Department of Transportation

MEMORANDUM

SUBJECT: ZC Case No. 21-18 – 4608-4618 14th Street NW

Figure 1 | Site Plan

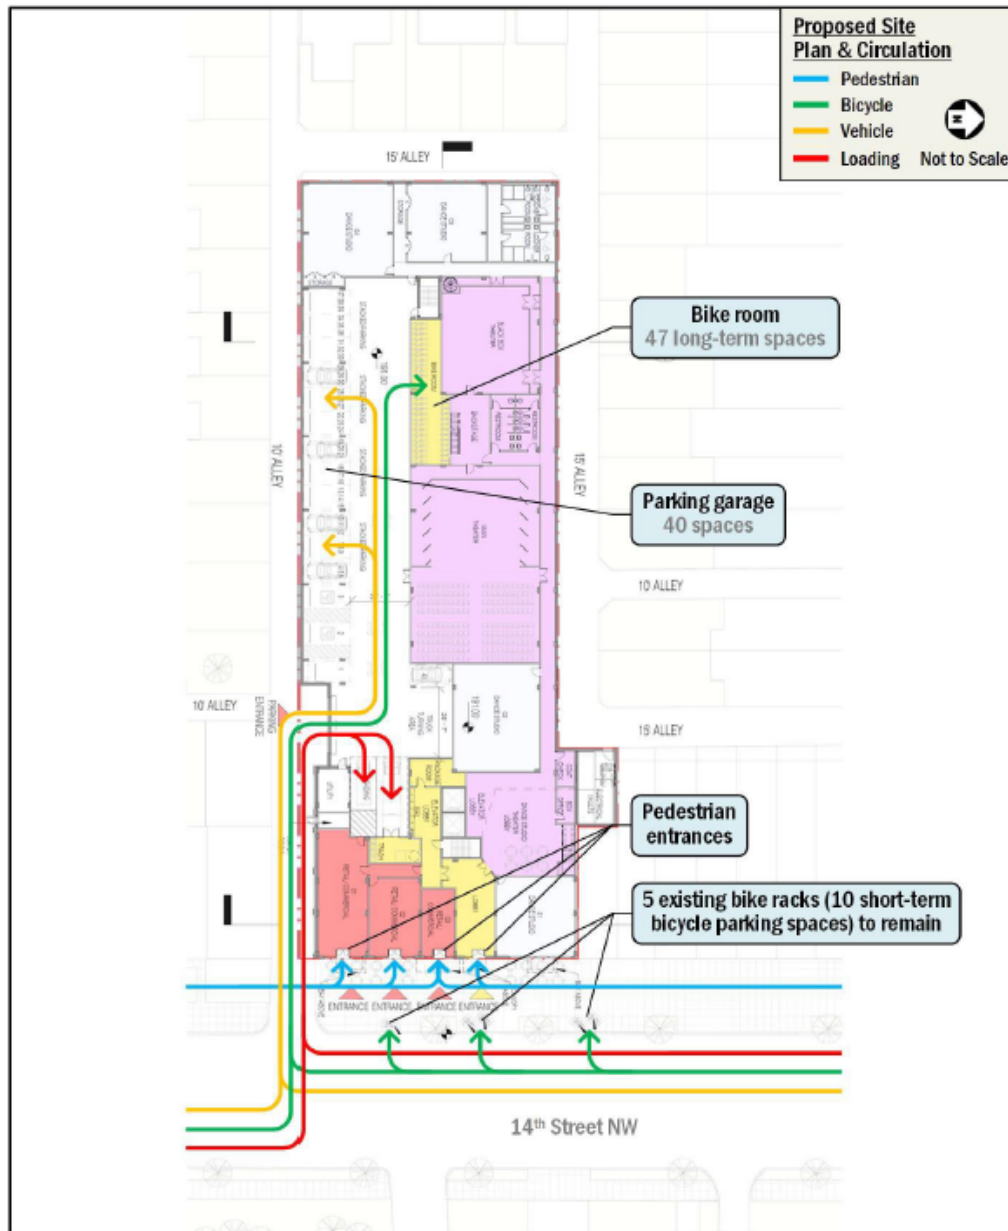
While the preliminary public space plans, shown above in Figure 1, are generally consistent with DDOT standards, there are several considerations that need to be reviewed in greater detail during the public space permitting process:

- An occupancy permit will be required for any portion of the outdoor café in public space along the 14th Street NW frontage;
- Building projections on 14th Street NW should not project more than 4-feet into public space;
- The final location of the expanded 19-dock Capital Bikeshare station;
- The design and installation of the safety improvements at the intersection of 14th Street NW & Crittenden Street NW;
- The addition, and final location, of a street tree on the 14th Street NW frontage; and
- The final location of the five (5) short-term bicycle racks to accommodate 10 short-term bicycle parking spaces.

Figure 4 | Existing Pedestrian Network

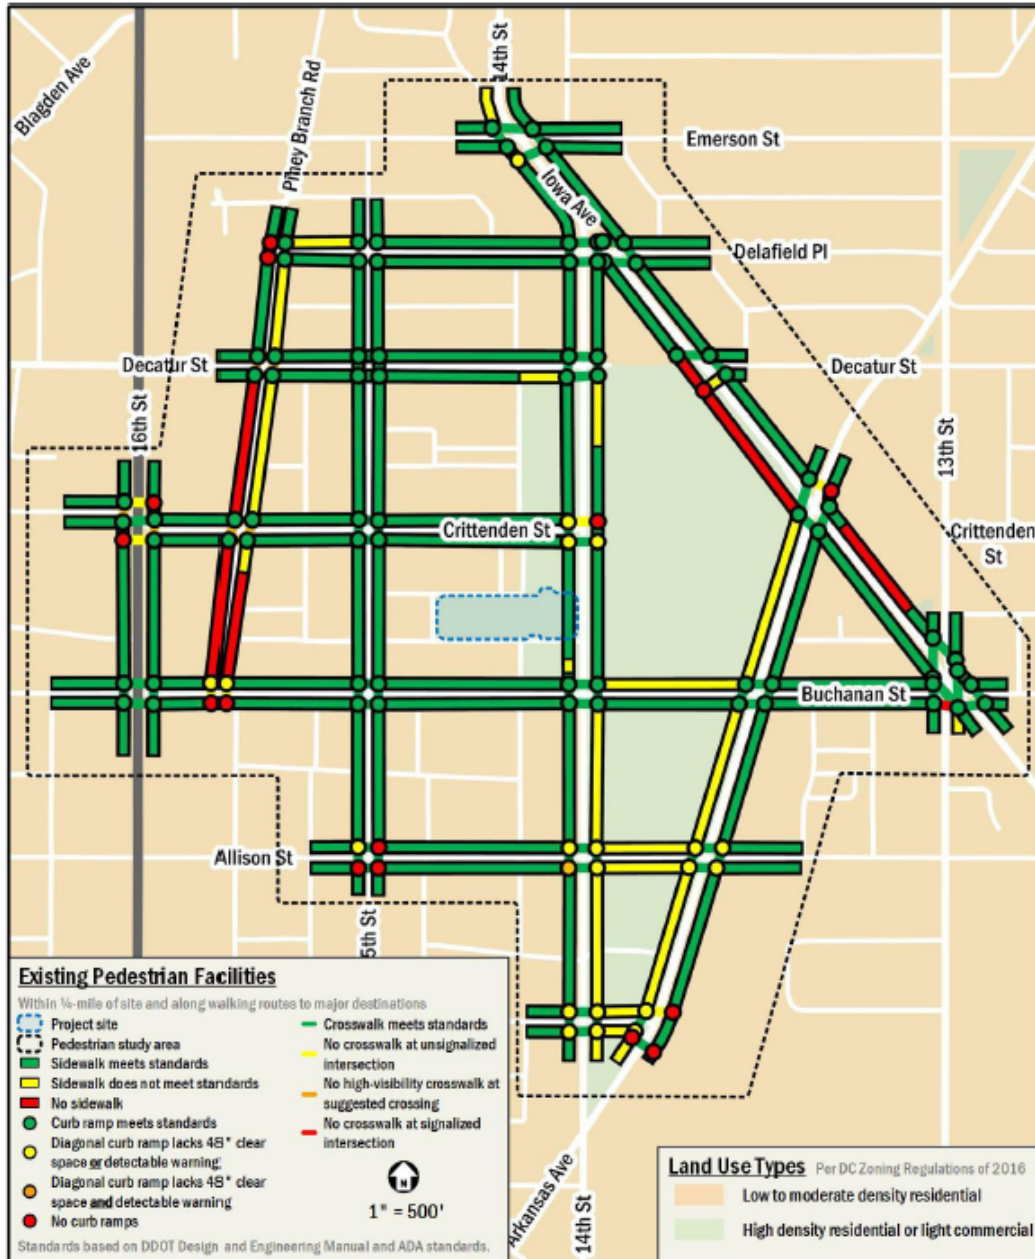
The Applicant's inventory of existing pedestrian infrastructure, as shown in Figure 7 below, demonstrates that most sidewalks in the immediate vicinity of the site are currently constructed with appropriate widths and include accessible curb ramps, with the exception of the intersection of 14th Street NW and Crittenden Street NW.

The Applicant should bring the intersection of Crittenden Street NW and 14th Street NW up to standard and add additional pedestrian countermeasures, as that intersection is an uncontrolled pedestrian crossing that will have additional use due to this development. The following upgrades should be made to this intersection, subject to DDOT approval:

- ADA ramps upgraded on all four legs of the intersection;
- New high-visibility crosswalk on the north leg of the intersection;
- Assessment of condition and restriping (if needed) of existing crossings; and

- Curb extensions on all four legs of the intersection, including removing parking from the middle of the intersection.

In conjunction with a robust TDM program, DDOT finds these intersection improvements to be acceptable and appropriate mitigation. DDOT notes that the final design of the curb extensions, curb ramps, and crosswalks will occur during public space permitting.
